87C196KR SPECIFICATION UPDATE

Release Date: January, 1997

Order Number: 272861-002

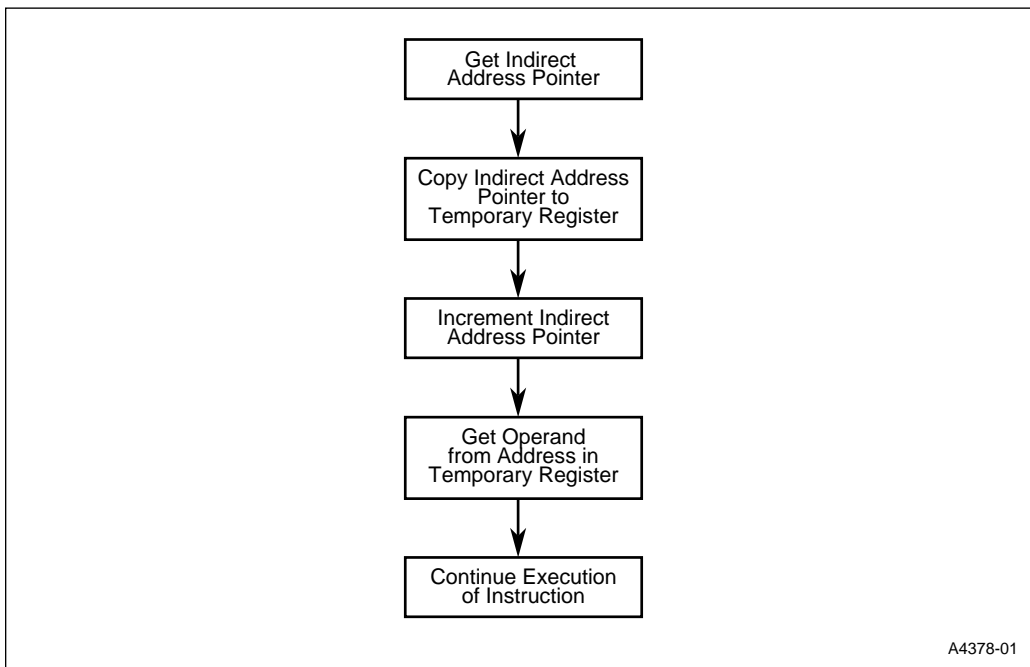
PROBLEM: For indirect addressing with autoincrement, a pointer that points to itself results in an access to the incremented pointer address rather than the original pointer address.

The CPU stores the pointer's value in a temporary register, increments the pointer, then accesses the operand at the address contained in the temporary register, as shown in this flowchart.

WORKAROUND: Avoid using an indirect address pointer that points to itself.

Figure 1. 16-bit System with EPROM

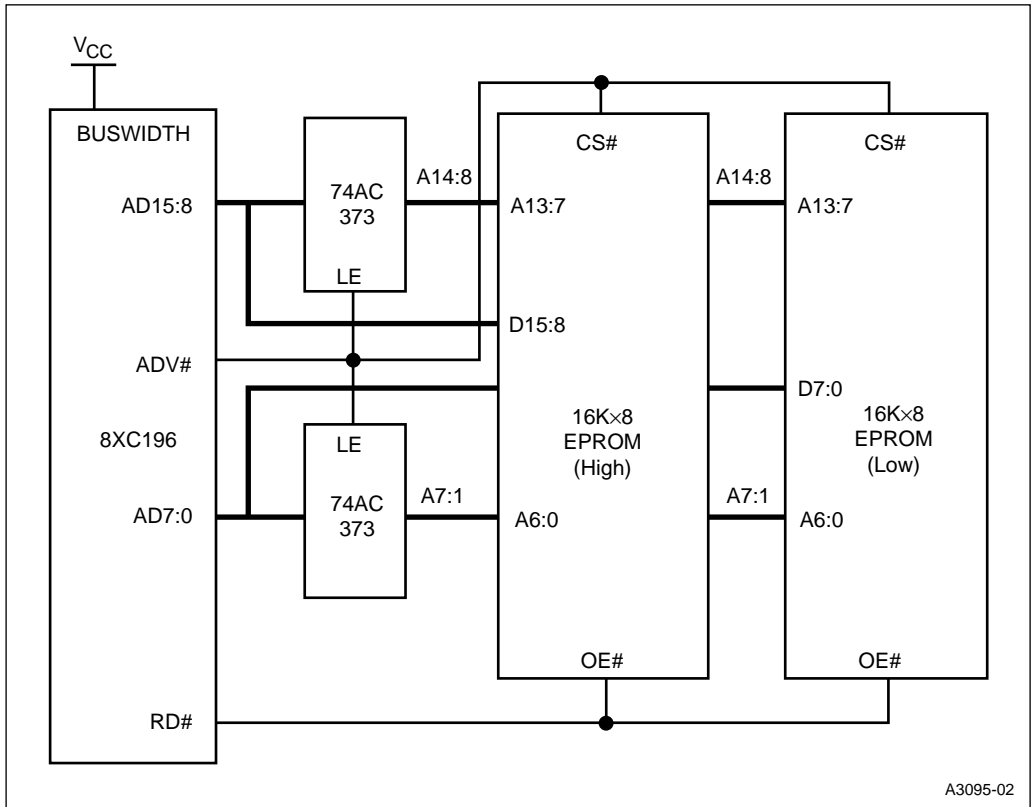
001. *High address inputs to the low EPROM should be A14:8 in Figure 15-18.*

ITEM: The next revision of the user's manual will include the following corrected graphic.
